UNITED STATES PATENT AND TRADEMARK OFFICE

APPLICATION NO.	FILING DATE	FIRST NAMED INVENTOR	ATTORNEY DOCKET NO.	CONFIRMATION NO.
10/072,247	10/23/2001	Daniel J. Cook	39726/29361	4051
1688	7590	12/15/2004	EXAMINER	
POLSTER, LIEDER, WOODRUFF & LUCCHESI 12412 POWERSCOURT DRIVE SUITE 200 ST. LOUIS, MO 63131-3615			PATEL, MITAL B	
			ART UNIT	PAPER NUMBER
			3743

Office Action Summary

DETAILED ACTION

FIG. 1

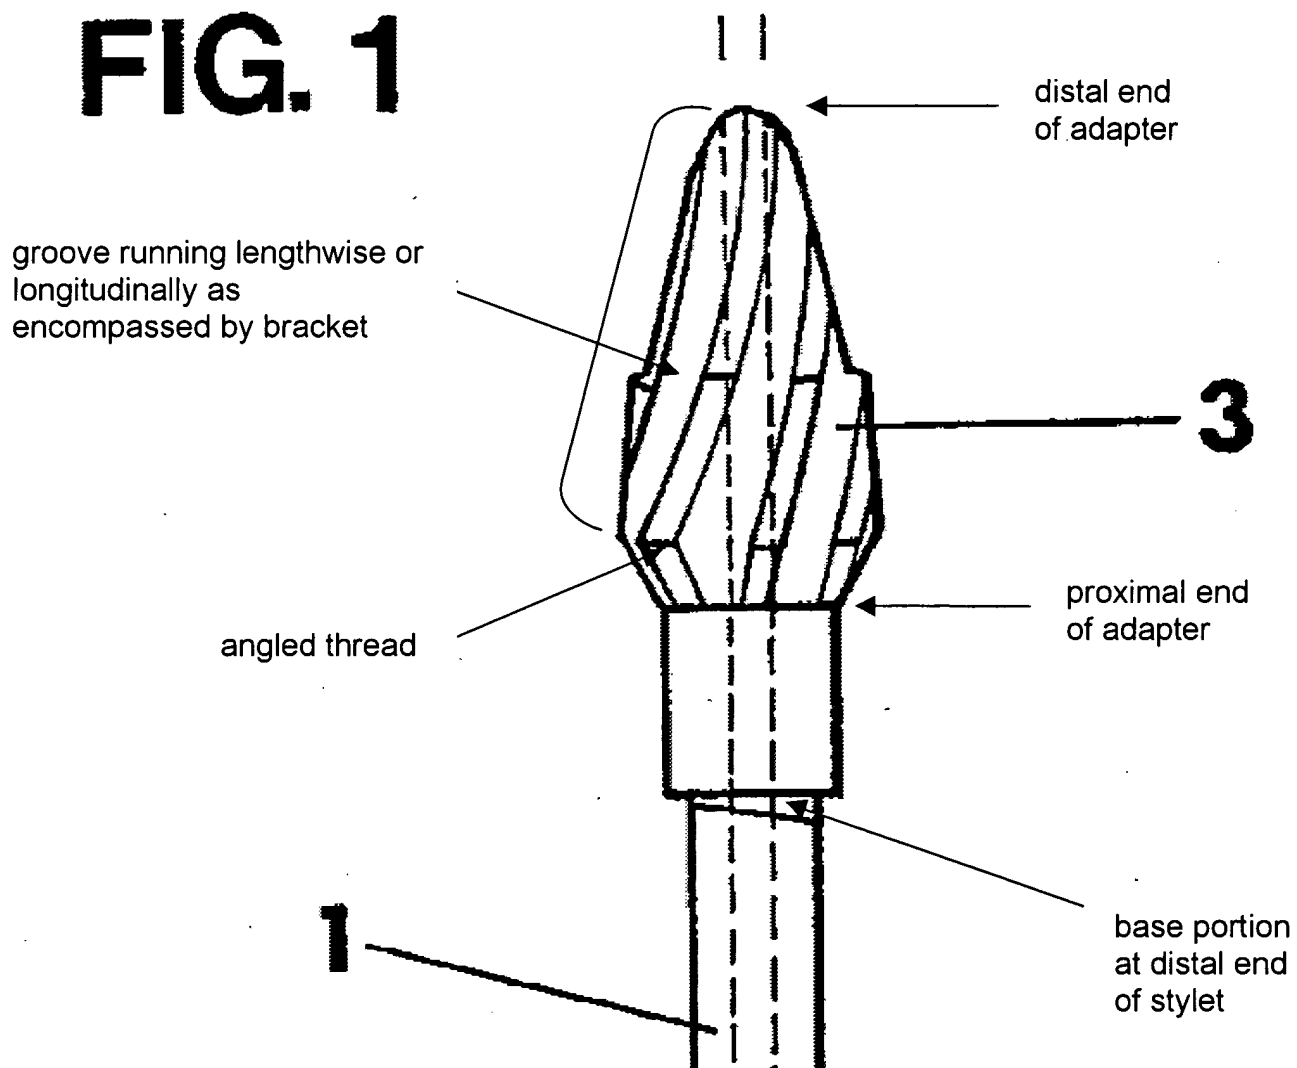
10. **As to claim 6**, DiPietropolo teaches an endo-tracheal tube retainer wherein an exterior surface of the connection adapter **3** comprises a plurality of longitudinal grooves **(Please see Fig. 1 attachment below; Also note that longitudinal is defined in Merriam-Webster's Collegiate Dictionary, 10th Ed. as placed or running lengthwise and the Examiner considers DiPietropolo to teach grooves running lengthwise on the adaptor from one end lengthwise to the other end; furthermore, Applicant recites longitudinal grooves on an exterior surface and does not recite longitudinal grooves running along the entire length of the exterior surface of the adaptor)** permitting passage of air and fluids past the endo-tracheal tube retainer after insertion within an endo-tracheal tube; and a plurality of threads angled **(See Fig. 1 attachment below)** to facilitate insertion of said endo-tracheal tube retainer within an endo-tracheal tube, but hindering withdrawal of said endo-tracheal tube retainer from said endo-tracheal tube **(Please note that given the structure the device is inherently capable of performing the functions set forth)**.

11. **As to claim 8**, DiPietropolo teaches an endo-tracheal tube retainer wherein the longitudinal grooves are equi-spaced around the connection adapter **3** exterior surface **(See Fig. 1 attachment below)**.

12. **As to claim 9**, DiPietropolo teaches an endo-tracheal retainer wherein there are at least four longitudinal grooves **(See Fig. 1 attachment below; please note only 3 are shown, the remaining grooves being on the other side of the adapter)**.

adaptor) permitting passage of air and fluids past the endo-tracheal tube retainer after insertion within an endo-tracheal tube; and a plurality of threads angled (**See Fig. 1 attachment above**) to facilitate insertion of said endo-tracheal tube retainer within an endo-tracheal tube, but hindering withdrawal of said endo-tracheal tube retainer from said endo-tracheal tube (**Please note that given the structure the device is inherently capable of performing the functions set forth**).
